## RE: Oakdale West Estate Stage 3 Development (SSD-9794683) – Response to TfNSW RFI

**Table 1: TfNSW Comments (18/03/2021) and Ason Group Response**

Revised Site Plans

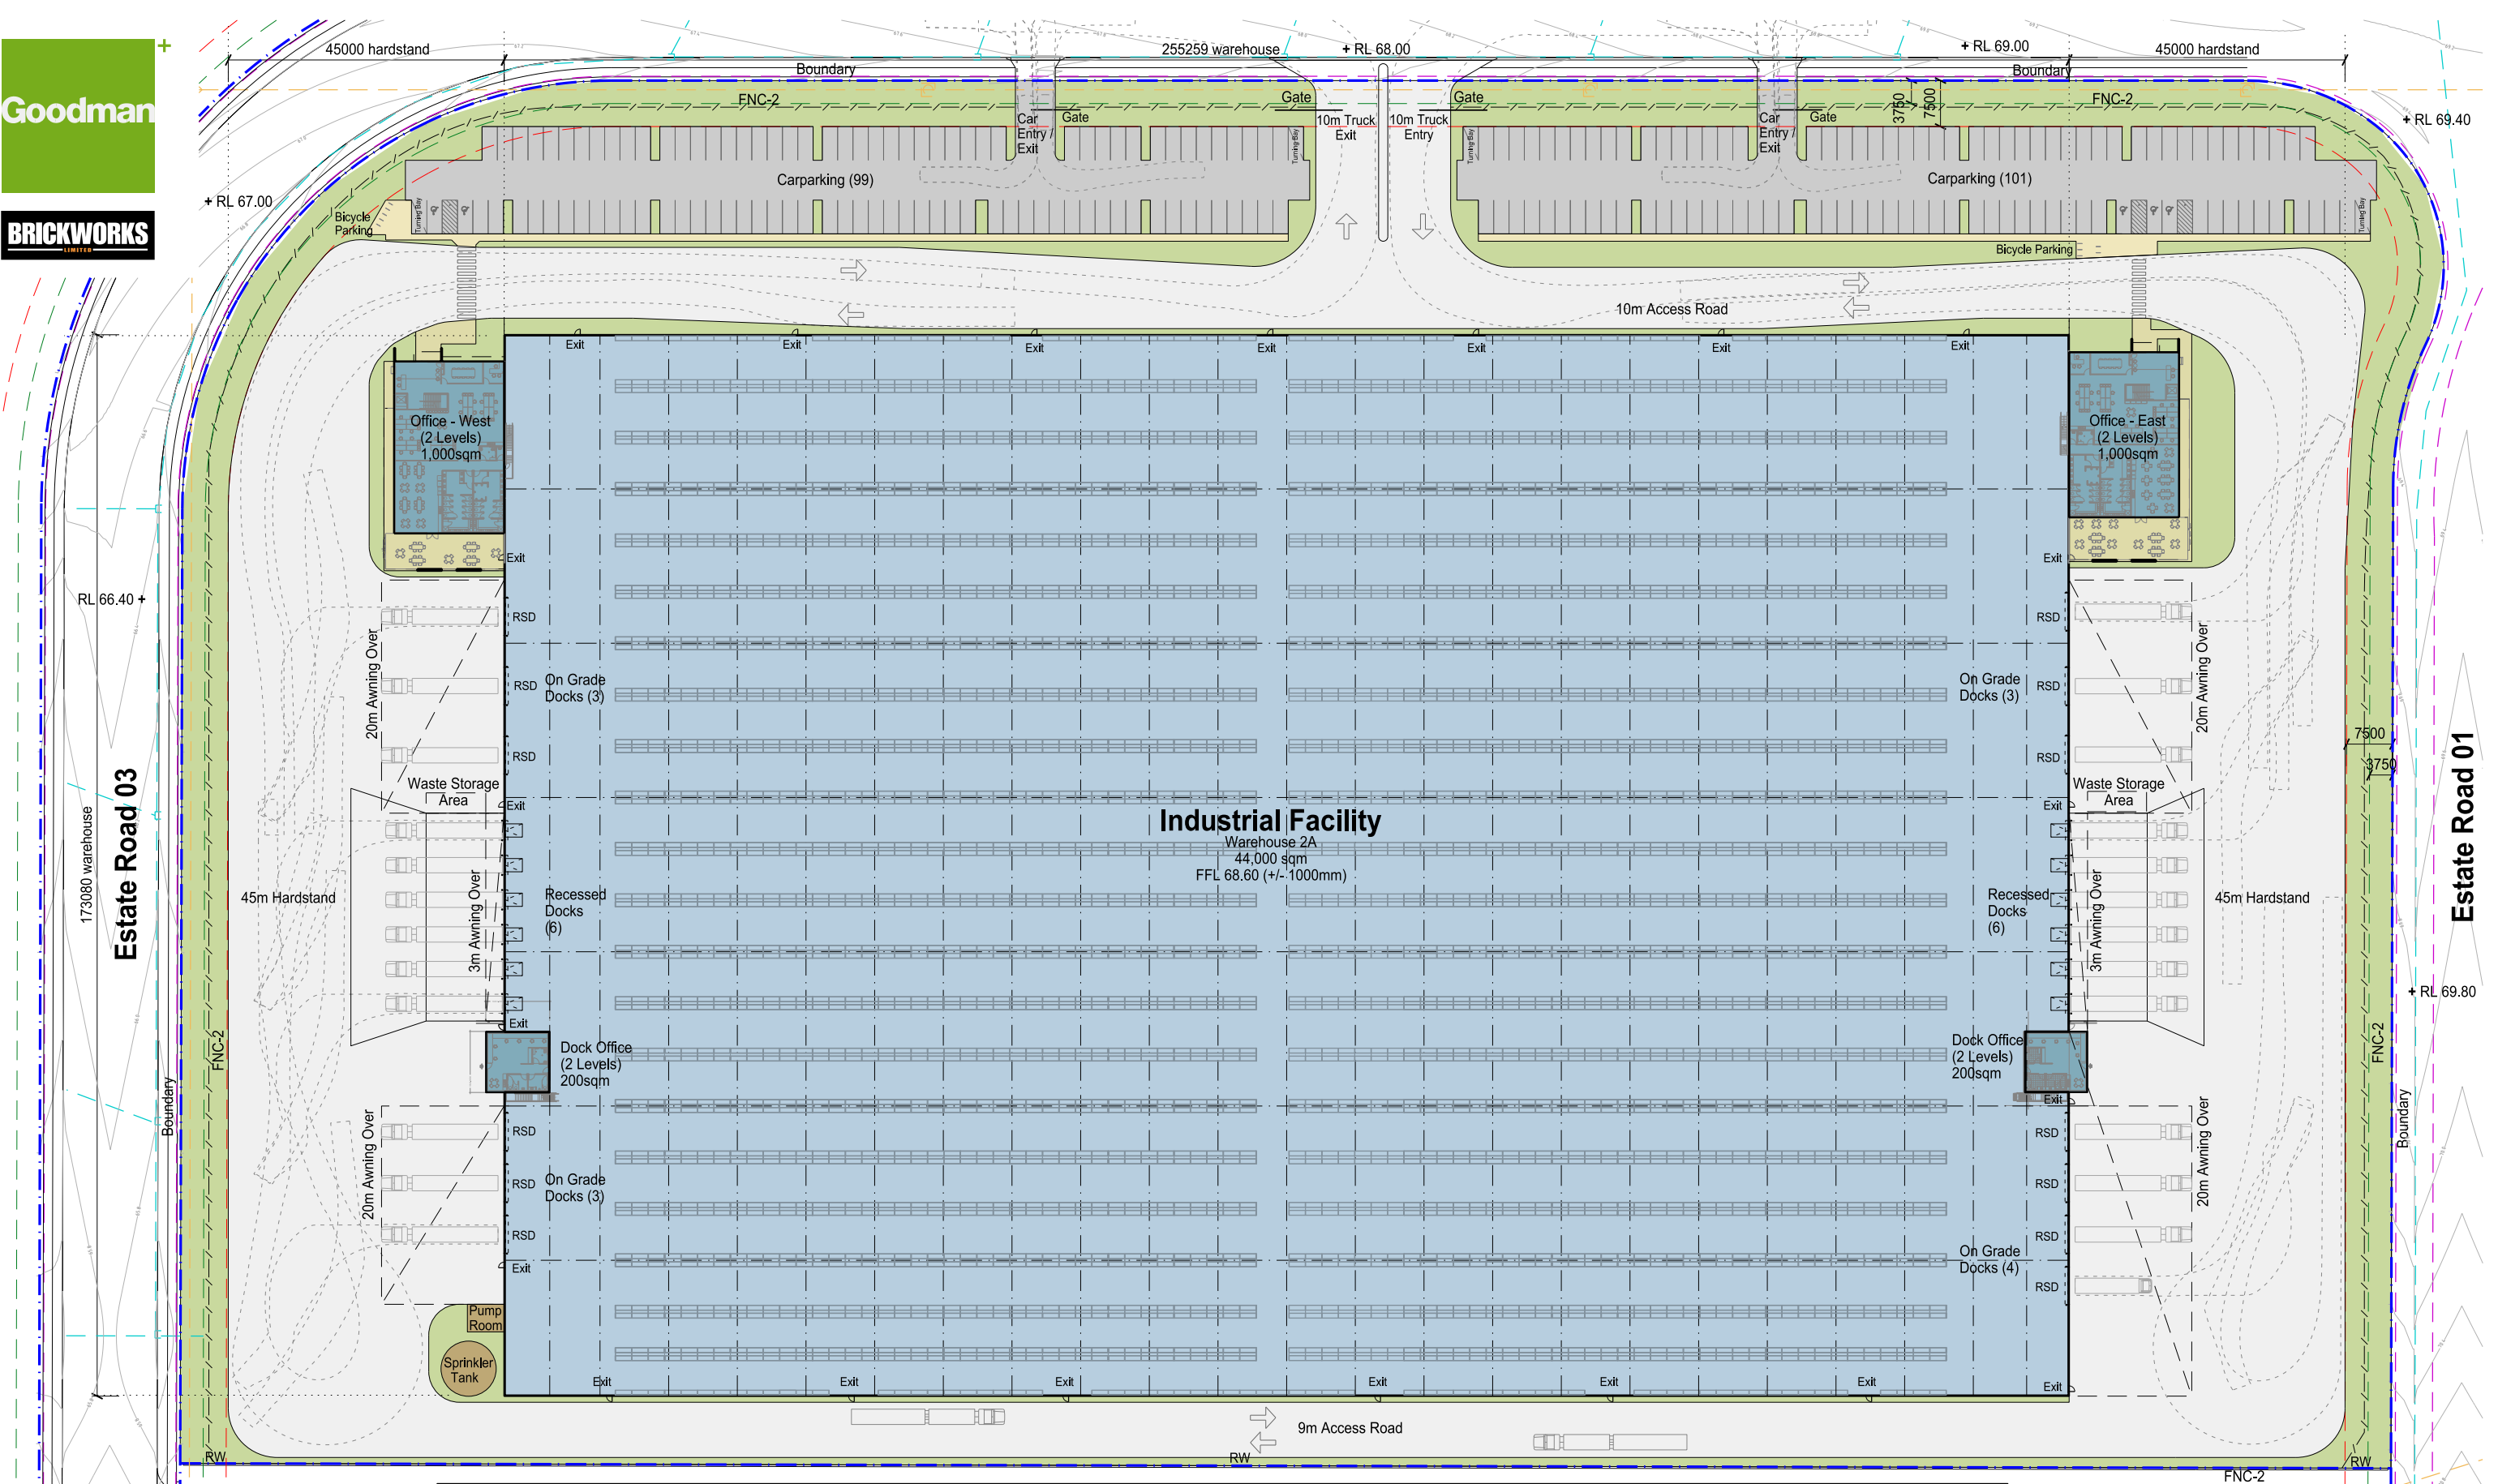
<b>Vehicular Access and internal road network</b>		
10	<p><b><u>Comment:</u></b></p> <p>The access for vehicular parking for building 2C is located in the centre of the development Lot (approximately 90m from the future SLR). Ideally the location of the vehicular access should be provided for away from intersections of major roads.</p> <p><b><u>Recommendation:</u></b></p> <p>Relocate the access for vehicular parking for building 2C north away further from the intersection of SLR.</p>	<p>Based on SIDRA modelling undertaken at the intersection of Estate Road 03 and future SLR as part of the OWE MOD 3 assessment, the maximum queue length from the future SLR is approximately 62 metres at Estate Road 03 during road peak hours (during peak season).</p> <p>Therefore, it is considered that the proposed location of access for vehicular parking for Building 2C provides sufficient queuing storage for the intersection of Estate Road 03 and future SLR</p>

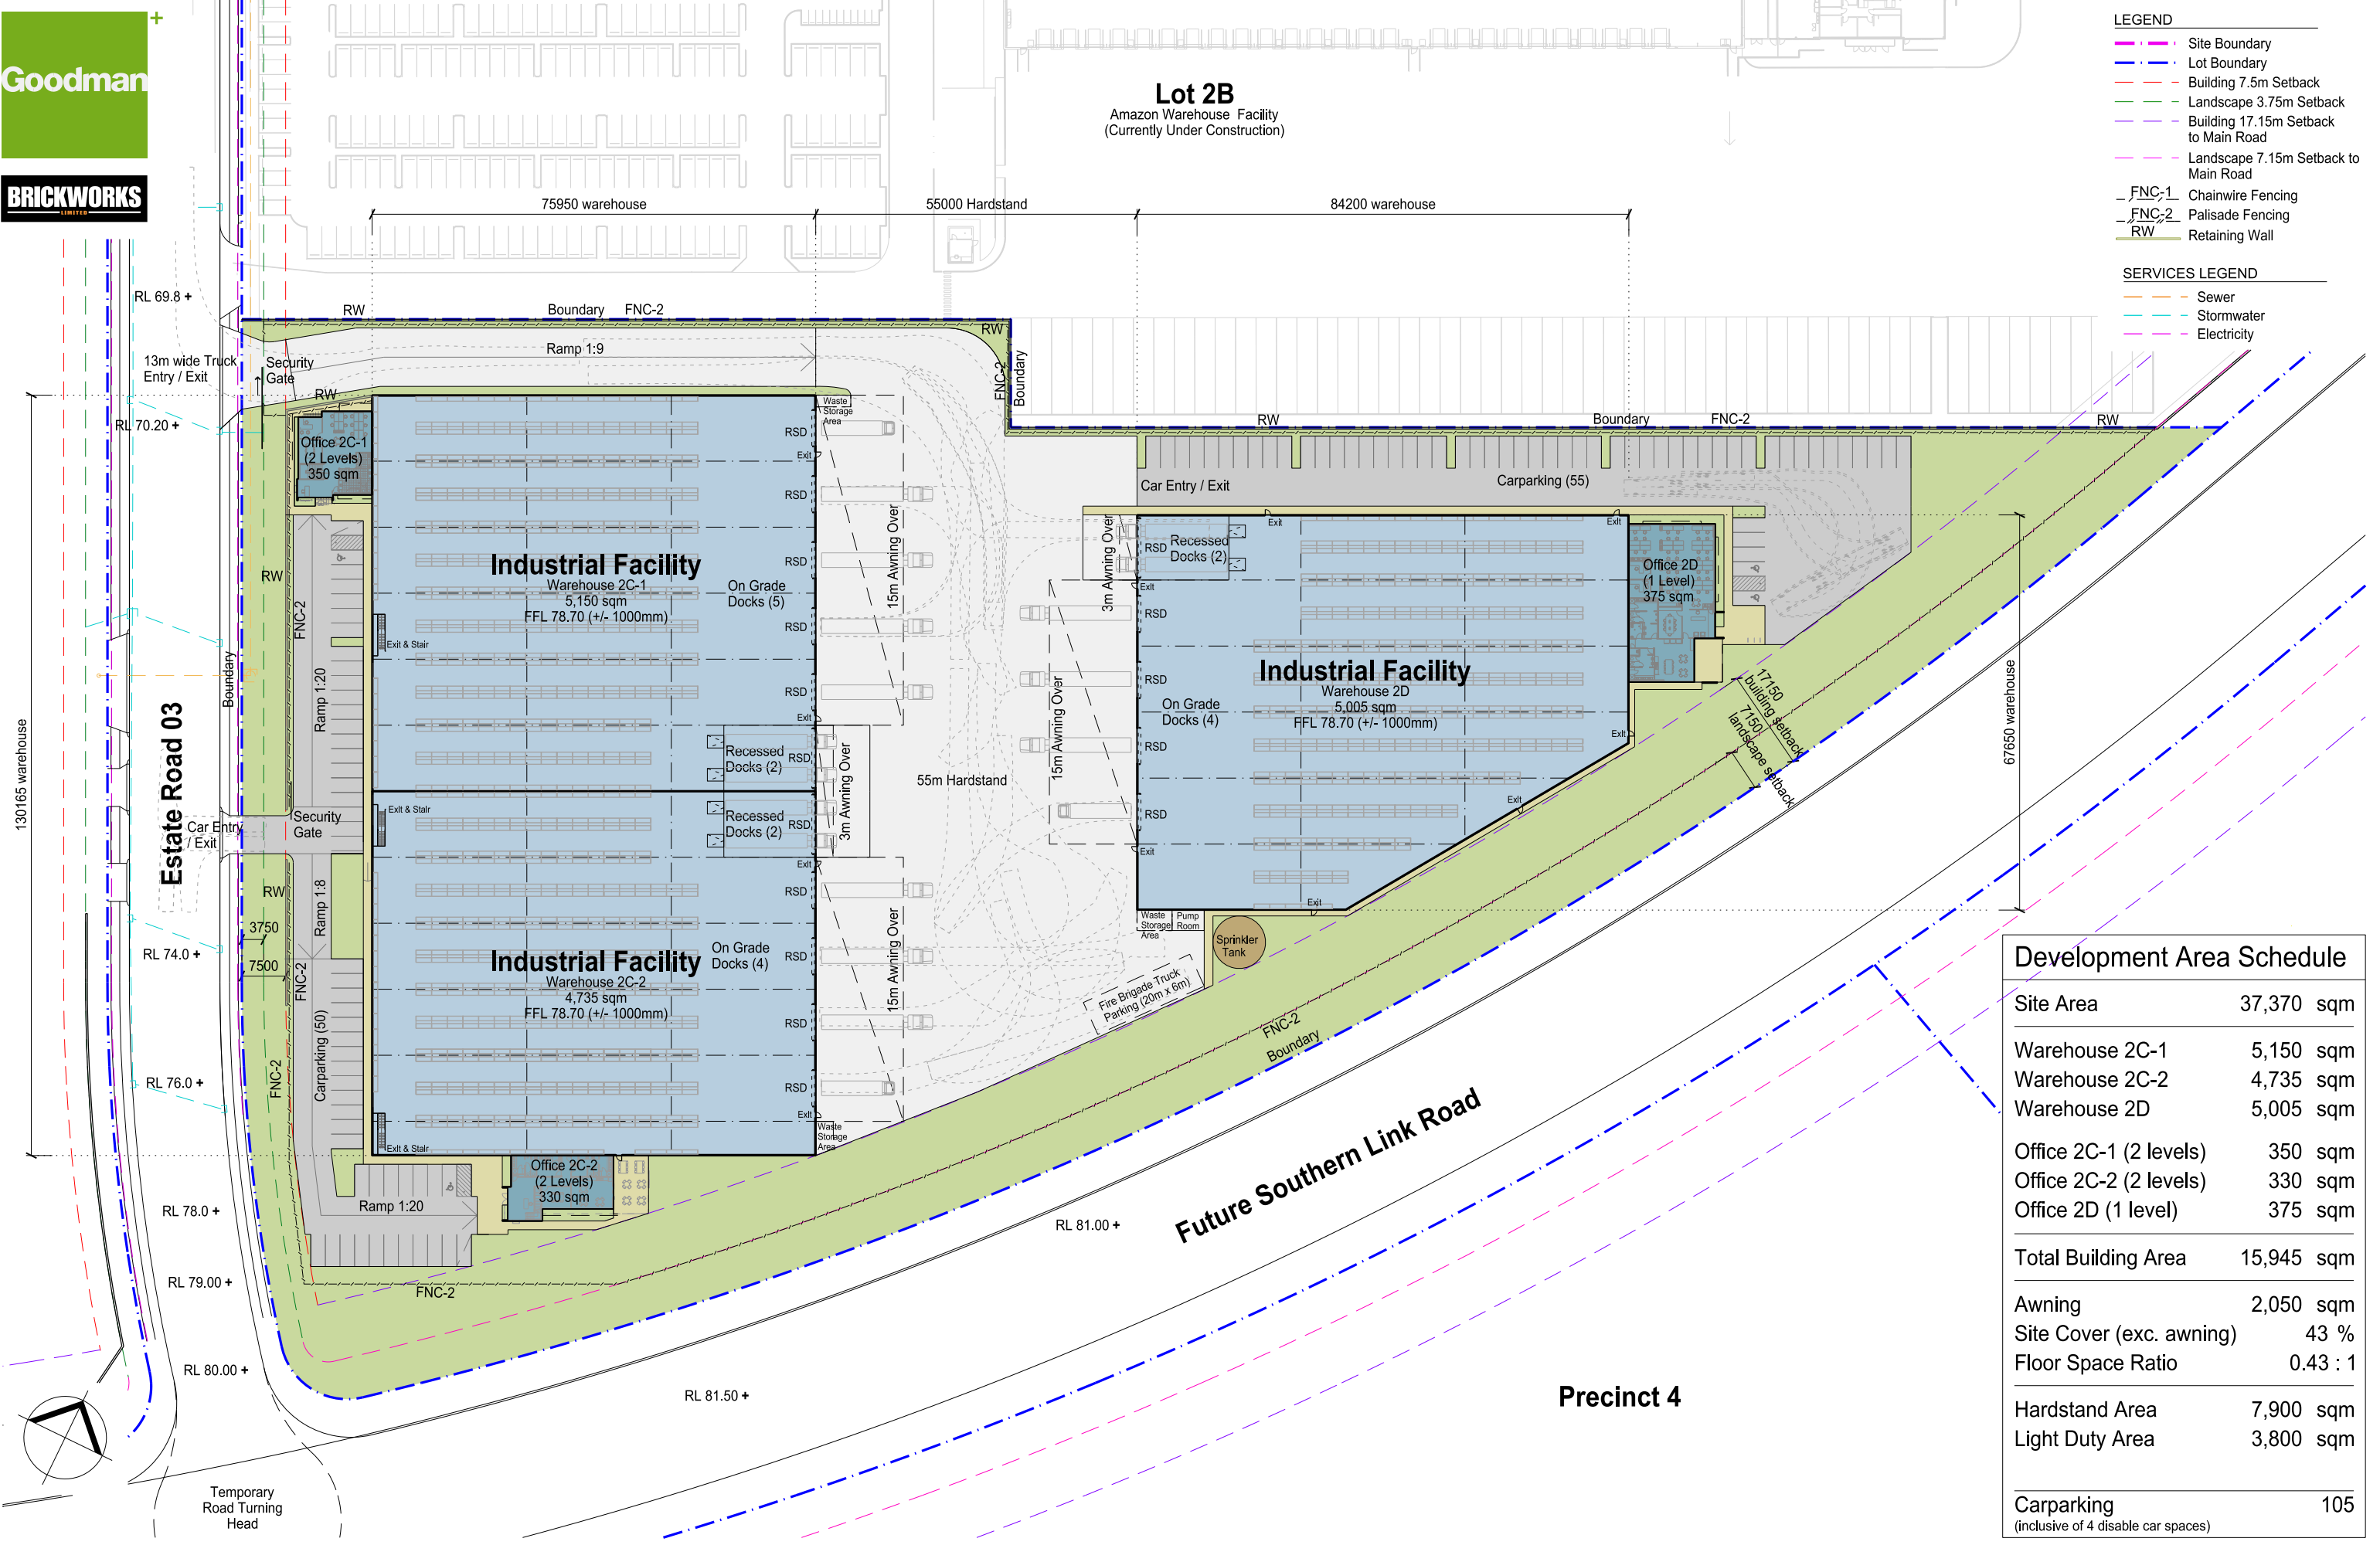
6	<p><b><u>Comment:</u></b></p> <p>It is unclear from Figure 7 provided in the TA whether Building 2D parking area will be accessed by both heavy vehicles and cars via the same driveway, or separately.</p> <p><b><u>Recommendation:</u></b></p> <p>The proponent should confirm whether there will be separate car/heavy vehicle access for Building 2D and provide justification if there is not. Sharing the access road will result in light vehicles mixing with a large amount of heavy vehicles.</p>	<p>Proposed Building 2D will provide only 55 on-site car parking spaces within a dedicated car parking area completely separated from the commercial areas and operational loading bays.</p> <p>It is noted that traffic generation of the proposed Building 2D car parking area is mainly related to the staff who will have detailed onsite briefing and inductions prior to the operation of the site. Same principle applies to the truck drivers attending Building 2D whom will be provided with a Code of Conduct and will be made aware of any possible conflict with the light vehicle movements.</p> <p>In any event the traffic generation of the proposed Building 2D in accordance with the traffic report now on exhibition has been estimated to be 9 veh/hr (light and heavy vehicle combined), which is considered minimal hence it is not anticipated to have significant conflict between these vehicles in such a slow speed environment.</p> <p>Having regard to the above, while the light and heavy vehicles will share the access, this will be managed to ensure safety of users.</p>
